MAJOR PROJECT ASSESSMENT
Carlton United Brewery Site (MP 06_0171)

Director-General's
Environmental Assessment Report
Section 75I of the
Environmental Planning and Assessment Act
1979

February 2007

Figure 12 - Modification to O'Connor Street northern elevation and relationship of Block 9 to Main Park (red area recommended for deletion)

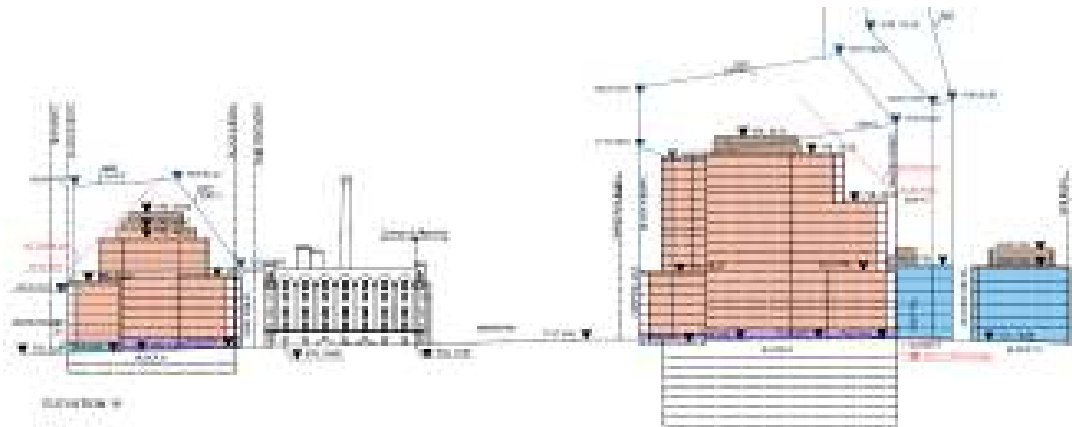
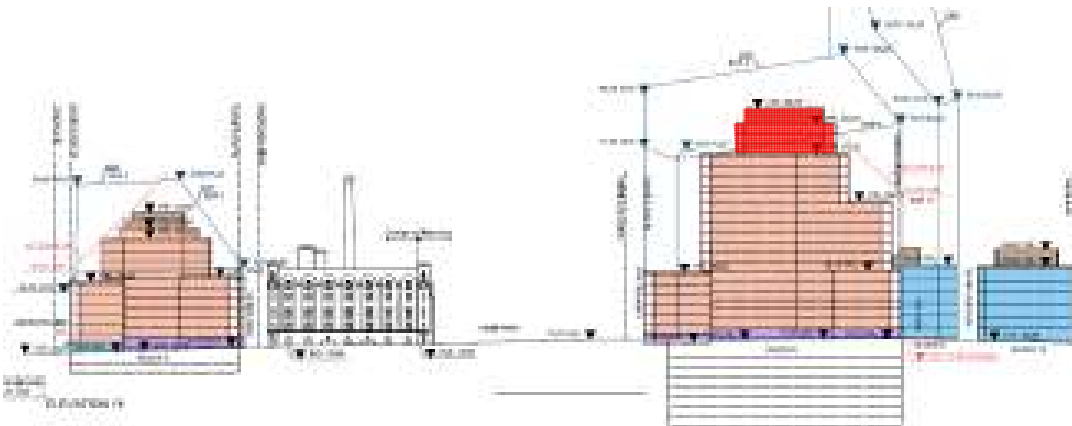
The Department raised concern that the building envelopes for Block 9 and Block 11 did not appropriately respond to their context due to their excessive bulk and scale. The Department advised that a revised scheme was needed to address the “wall like” visual impact that these blocks had on the proposed large park and those areas of Chippendale to the south. The Department also raised concern with the Kent Road building envelopes as they appeared to be incongruous in their relationship with the surrounding building envelopes and built form constraints of heritage buildings.

The Department’s review of the Proponent’s modification has improved Block 9 in its relationship with the Park and Block 11. There are remaining issues with Block 9 and Block 11 and further modification is required to reduce apparent bulk and:

- with Block 9, the removal of the additional levels proposed in the modification as they detract from the slender tower envelope on Block 5 (Figure 15 and Figure 16), increase its apparent bulk, and do not contribute any further positive outcomes to the setback of Main Park (Figure 11 and Figure 12), and
- with Block 11, it is considered appropriate to reinforce the 15 metre frontage to Wellington Street (Figure 13 and Figure 13).

- to ensure that Block 9 is to be modified to show the height of the building envelope reduced from FRL 89.70 to plant height FRL 80.70 and habitable room height to FRL 75.70,
- to require further setbacks above an appropriate podium on Block 1, Block 5, and Block 9;
- to establish a maximum GFA for Block 9 of 22,053 square metres, and
- to establish a maximum GFA across the CUB Site of 235,000 square metres.

- (a) the building is reduced in height by 3 habitable levels,
- (b) the height of the building envelope (including plant height) does not exceed RL 80.70;
- (c) the height of the building envelope for habitable areas do not exceed RL 75.70; and

Figure 16 - Modification to Kent Road western elevation (red area recommended for deletion)

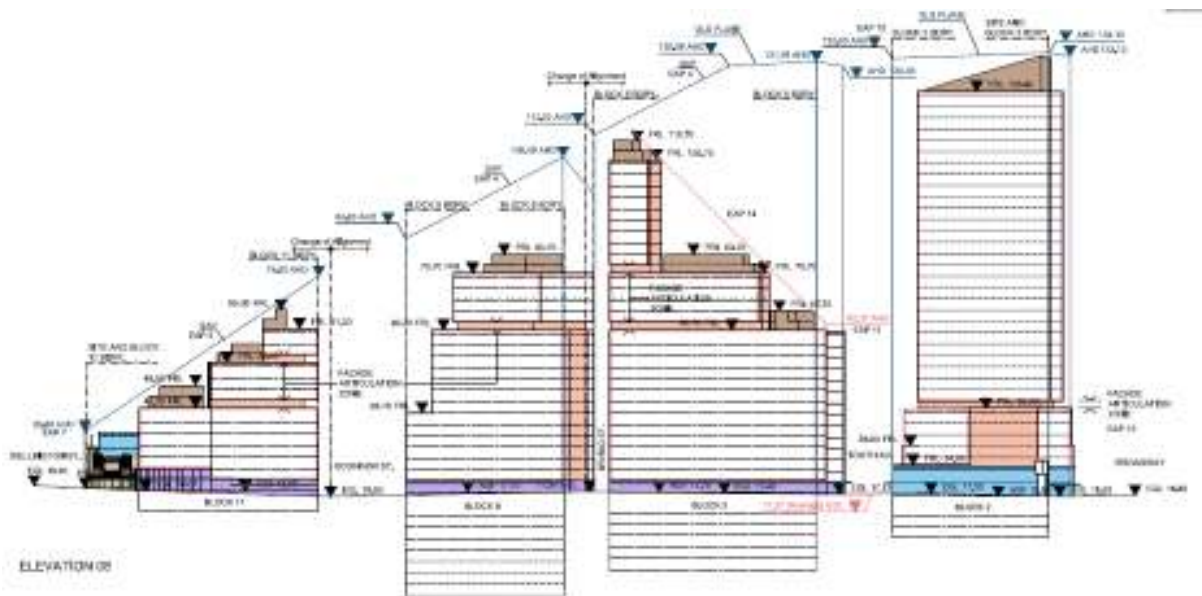
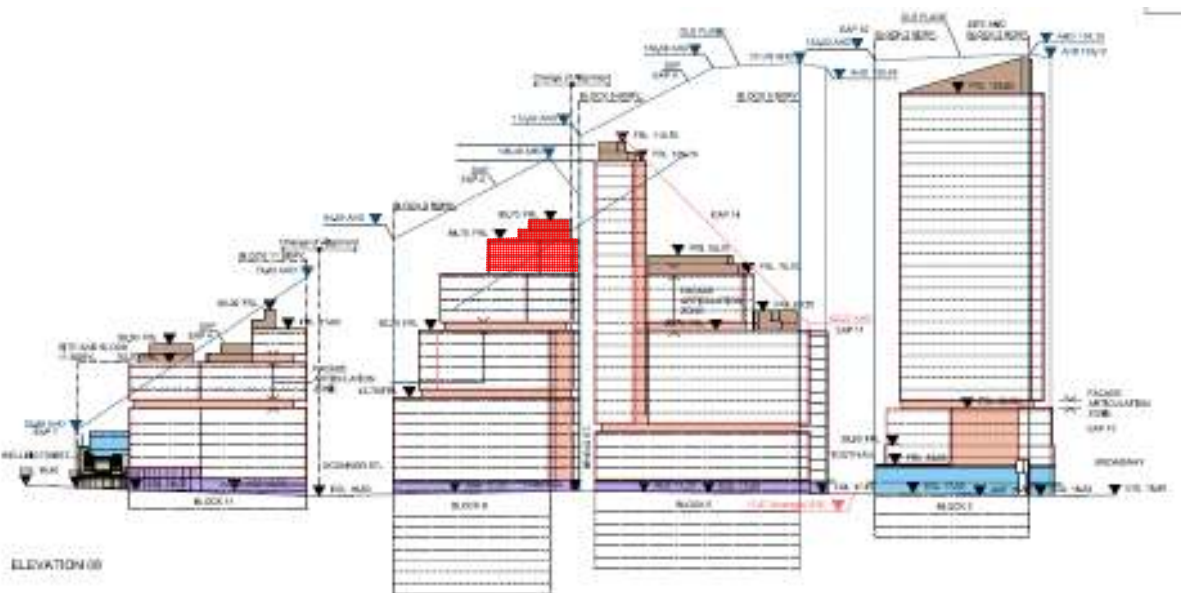
While the elevation plan show a definite improvement between the articulated and non-articulated parts of the building, the Proponent's modifications to the western edge of Kent Road do not resolve the issue of scale. The elevation plan's colouring of the non-articulated parts of the building obscure the fact that the depth and height of the non-articulated areas are too fine (Figure 16). Consequently, the architectural strength of the non-articulated areas (especially the horizontal areas) shown in the elevation is unlikely to eventuate when viewed as a pedestrian along Kent Road. Indeed, the visibility of the non-articulated parts of the building would invariably decrease as the views to the western elevation of Kent Road became more distant.

Figure 17 - Aerial View showing western frontage of Kent Road and southern frontage of Broadway in the Concept Plan (as lodged)

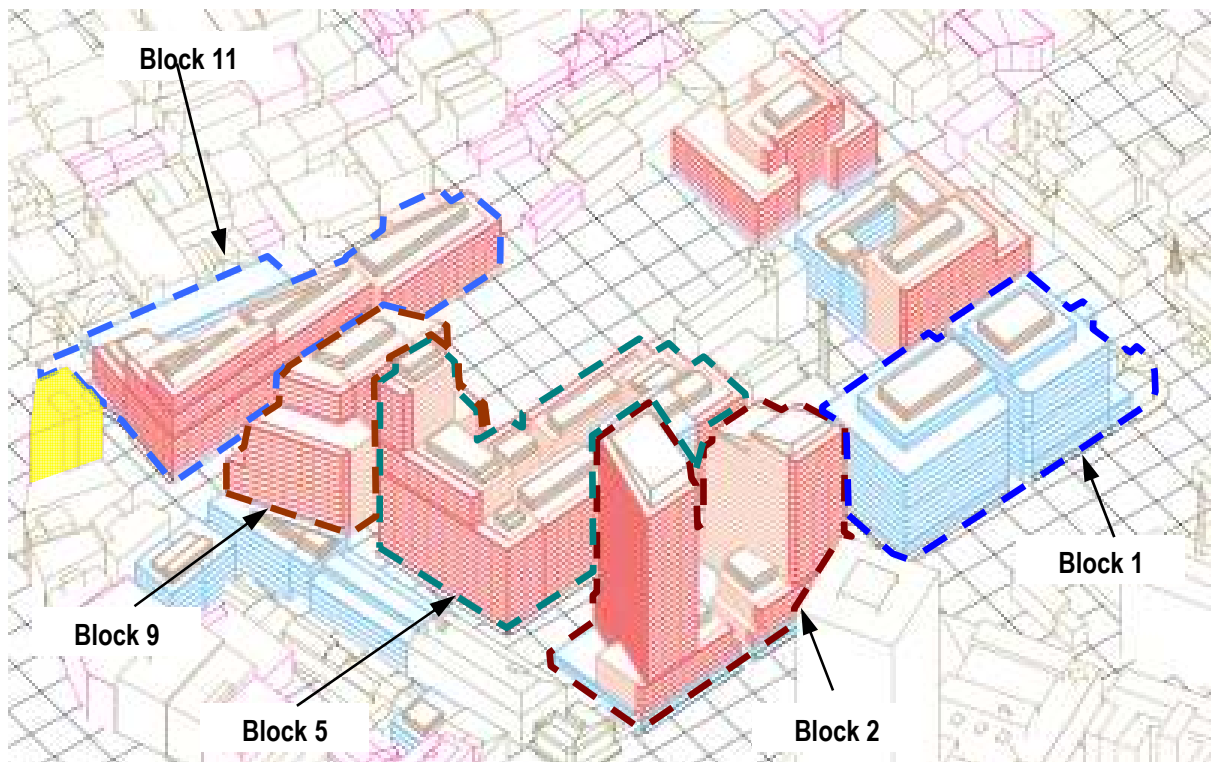
The solution to the scale relationship along Kent Road and Broadway is to use upper level building setbacks in conjunction with the proposed articulation zones. The Proponent already demonstrates their effectiveness on Block 2's Kent Road and Broadway frontages in the Concept Plan as lodged (

Figure 17) and with Block 11 responding to scale of the apartments at the corner of Kent Road and Regent Street (highlighted yellow in

Figure 17). Therefore, it would be appropriate to introduce upper level setbacks to Block 5 and Block 9 along Kent Road and to Block 1 along Broadway.

Figure 18 – Proposed street uses and Department recommended street activation zones (dashed red)

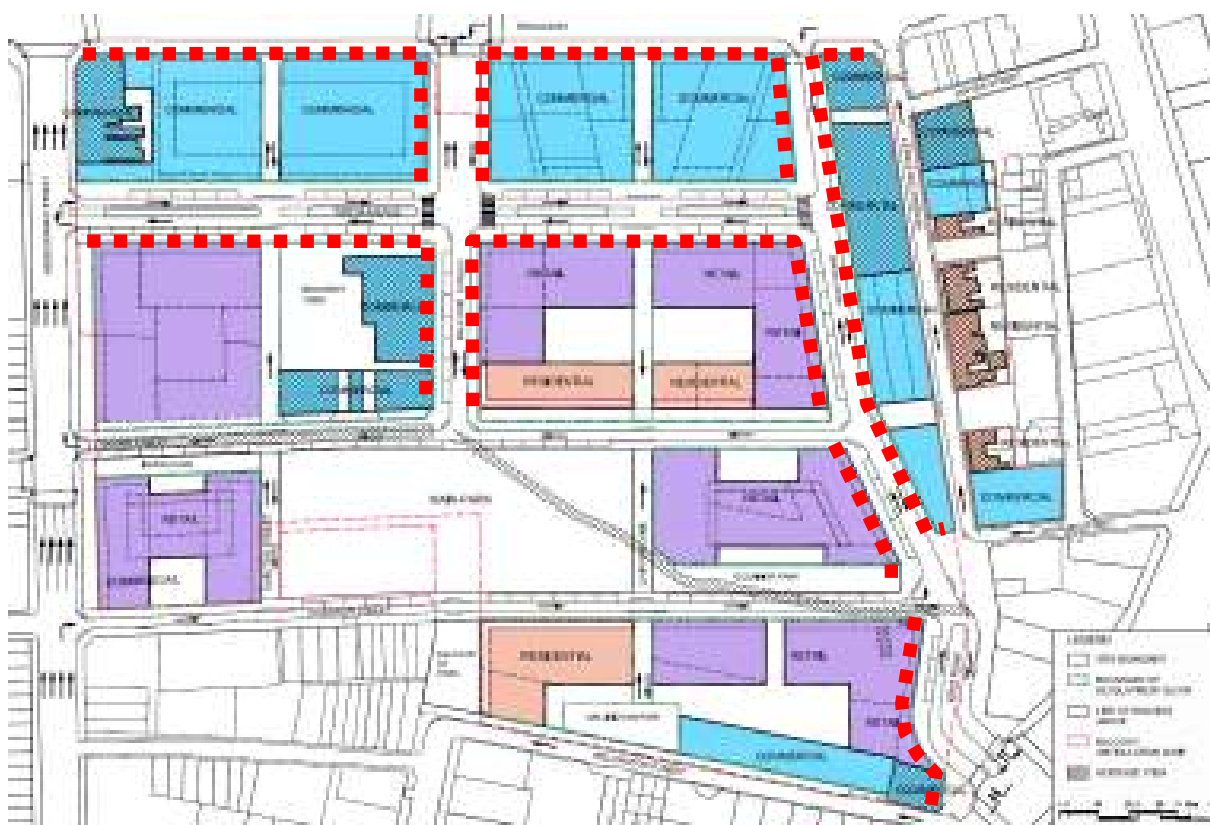
The Department agrees with the matter relating to lack of connectivity and notes that successful retailing streets with significant commercial offices are predominantly orientated north south in the Sydney CBD (such as Pitt Street Mall), not east to west as is the proposed Tooth Avenue. The Department comments that the ground floor land use plan suggests that options exist to achieve north to south retailing on Balfour Street and Kent Road and that Tooth Avenue's function may be more inline with the character of Martin Place, which provides work space/foyer for commercial offices.

The Proponent's justification for selecting Tooth Avenue as the 'High Street' arose as a result of the ground floors of the industrial heritage items in Balfour Street. The Proponent advises that as they are approximately one metre above the natural ground level making pedestrian access and disability requirements difficult. In addition, the industrial character of the Balfour Street frontage was not possible to provide glass shopfronts or shop awnings.

The Department considers that opportunities to achieve successful high streets are important. The site should ensure retailing and ground floor uses could ensure good connectivity to surrounding areas and are successful. Consequently the concept plan should not preclude the opportunity to allow retail uses to occur along Broadway provided the maximum retail component does not exceed the maximum GFA for retail uses within the CUB Site.

The Department recommends the concept plan be modified to allow retail uses along Broadway, Balfour Street and Kent Road to provide street activation and ensure active uses are encouraged.
